The State of New Hampshire
DEPARTMENT OF ENVIRONMENTAL SERVICES

RE: **Request for Action:** Pea Porridge Pond Middle & Little, D149004, Significant, Madison

Dam #D149004, Pea Porridge Pond Middle & Little Dam, Madison, Inspected on June 4th, 2020

A

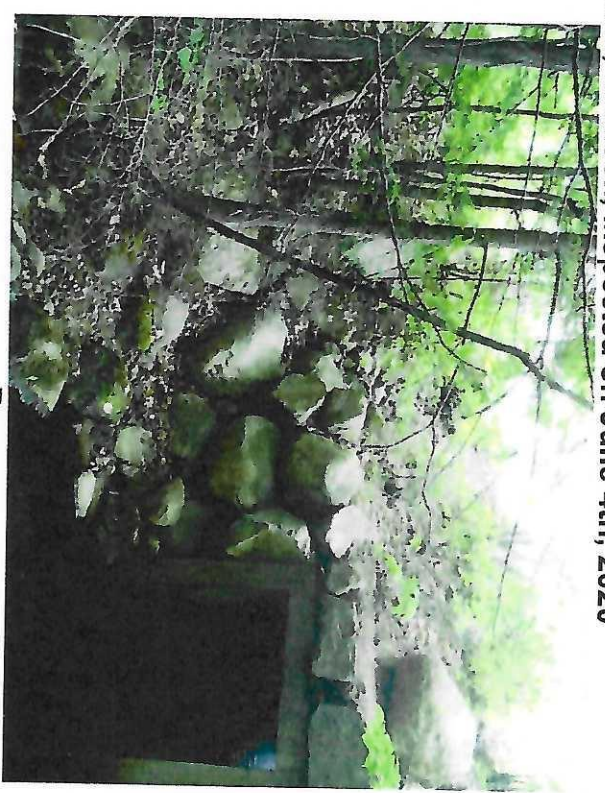
2. Cut all trees, brush and weedy growth from the footprint (earthen, stone and concrete embankment) of the dam and 15 ft. beyond the footprint of the dam to prevent damage to the dam from root penetration, blow down of the trees and to create a buffer zone to monitor the dam for seepage and other maintenance concerns. Areas to clear include:
 - a. Along the entire downstream slope of the embankment. The original design plans indicate that the embankment is close to 175' long, with 75' to the right of the outlet and 100' to the left. (See photos A, B and C);
 - b. The brush/weedy growth on the upstream slope of the embankment on both sides of the outlet structure. (See photos D and E); and
 - c. The inlet area to the auxiliary spillway and along its 160'+ length. The original design plans indicate that the spillway has a base width of 80' from inlet to outlet. (See photo F).

B

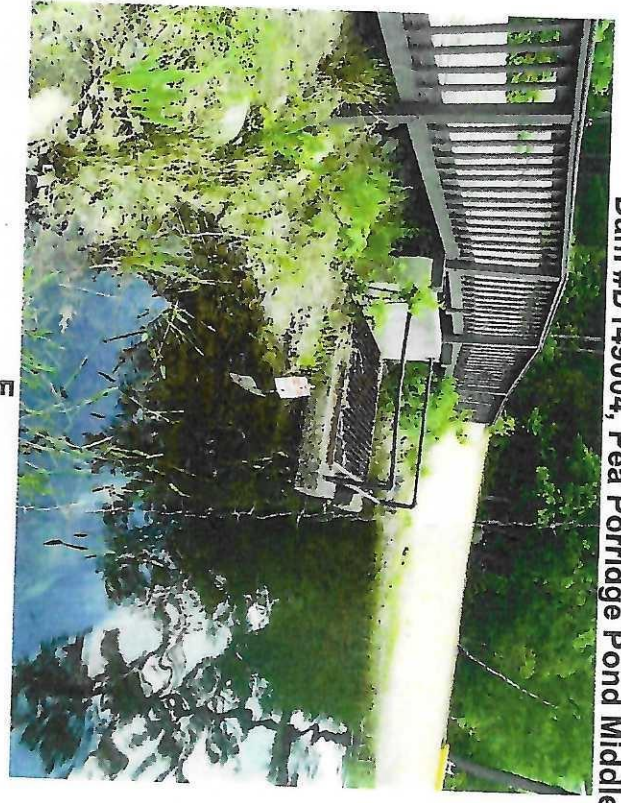
4. Monitor the leakage, seepage and areas of rust-colored iron bacteria in the following locations:
 - a. Interior left wall of the concrete drop inlet at the joint. (See photo G).;
 - b. Interior left wall at the beginning of the outlet culvert. (See photo G); and
 - c. Toe of embankment along the outlet's left channel. (See photo H).
